1546 NELSON STREET (COMPLETE APPLICATION)  
DE418104 - ZONE RM-5

**EXECUTIVE SUMMARY**

- **Proposal:** To rehabilitate and designate the existing character multiple dwelling (six units) and to develop a new three-storey multiple infill dwelling consisting of four rental units addressed from the lane to the rear of the existing site.

**DEVELOPMENT PERMIT STAFF COMMITTEE RECOMMENDATION: APPROVE**

Scale: 1/4" = 1'-0"  
DRAWING NO. **A110**

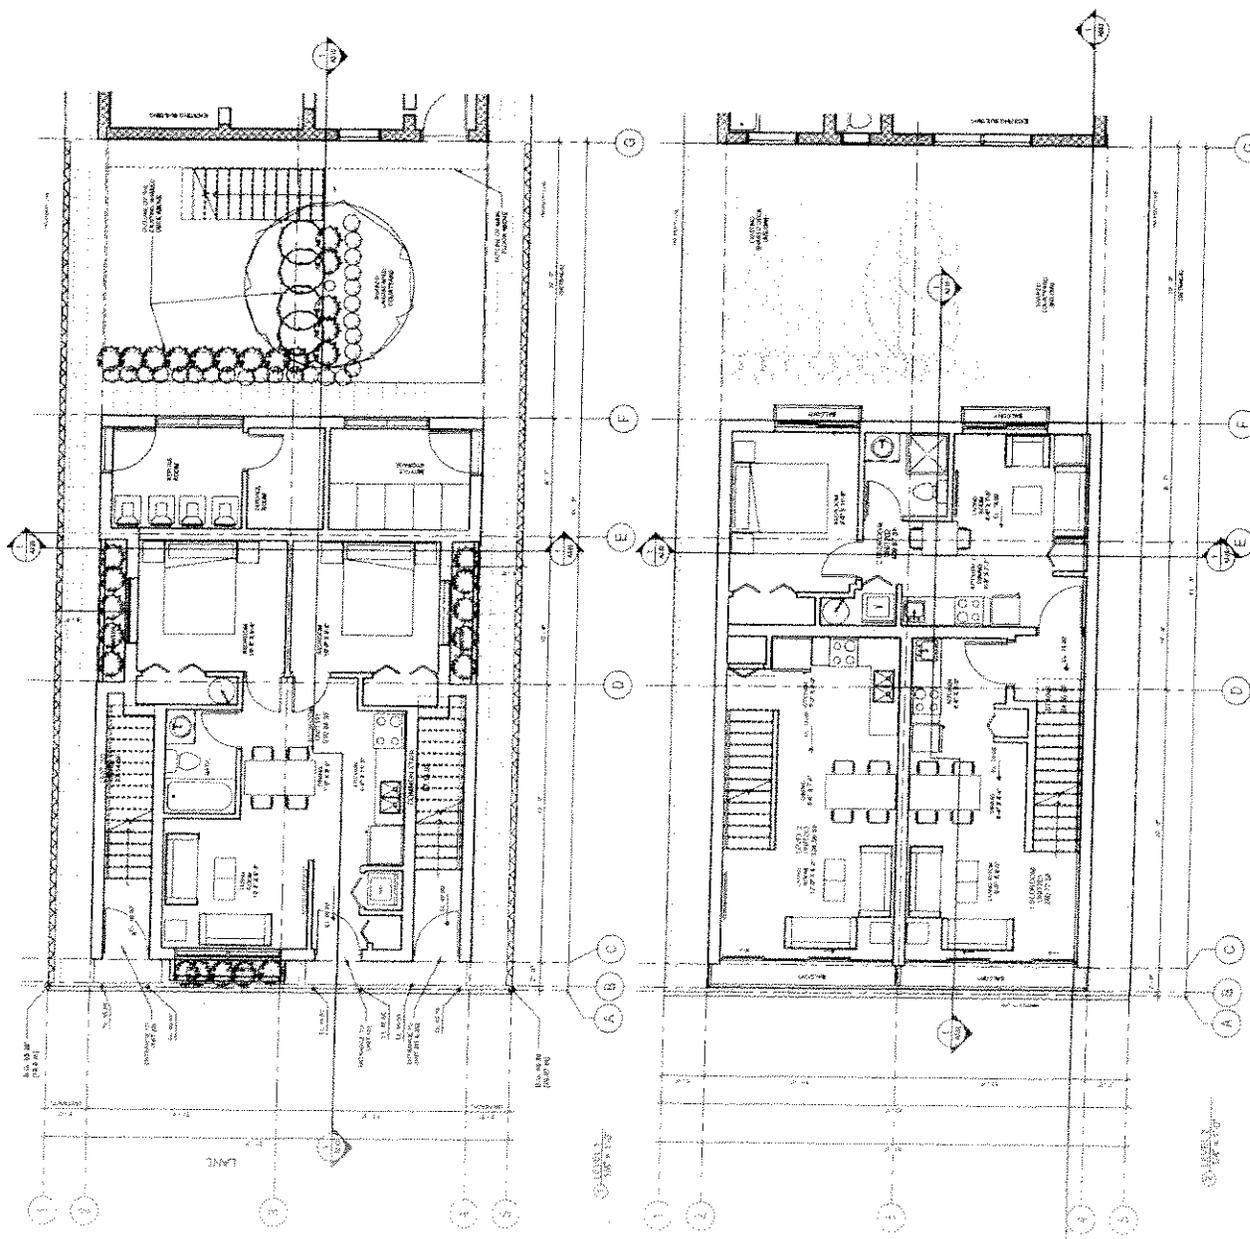
**1.1 design development to improve the shared courtyard expression and function as follows:**

- i. deletion of the existing deck;

**Note to Applicant:** The retention of the existing deck makes the shared courtyard less attractive to use by residents of the infill building and also reduces separation between buildings below minimum requirements as per Standard Condition A.1.1. To provide a common open space suitable for use by families with children and more generally improve shared amenity for residents of the infill building, the deck should be deleted.

- ii. Relocation of the service functions at grade level of the infill building to facilitate activation and animation of the courtyard by Unit 101;

**Note to Applicant:** Unit 101 at ground floor level of the infill building should have direct aspect from the bedrooms to the shared courtyard to improve livability of the unit and animate the grade level of the shared courtyard. This should be achieved by relocating garbage and bike storage areas. See also Condition 1.3.i regarding provision of private open space to this unit.

- i. provision of private patio to Unit 101;

**Note to Applicant:** This should be achieved in tandem with revisions to the layouts of the shared courtyard and Unit 101 as per Condition 1.1.

- ii. provision of external decks to Units 201 & 203;

**Note to Applicant:** Private open space proposed for family units at upper levels in the infill dwelling is not sufficient and should be improved. This can be achieved either through the provision of private decks inset into the building face or through the development of private rooftop spaces with direct accessibility from the family-oriented units immediately below. In either case, mitigation of direct overlook from proposed decks and balconies should be provided as per Condition 1.3.iii.
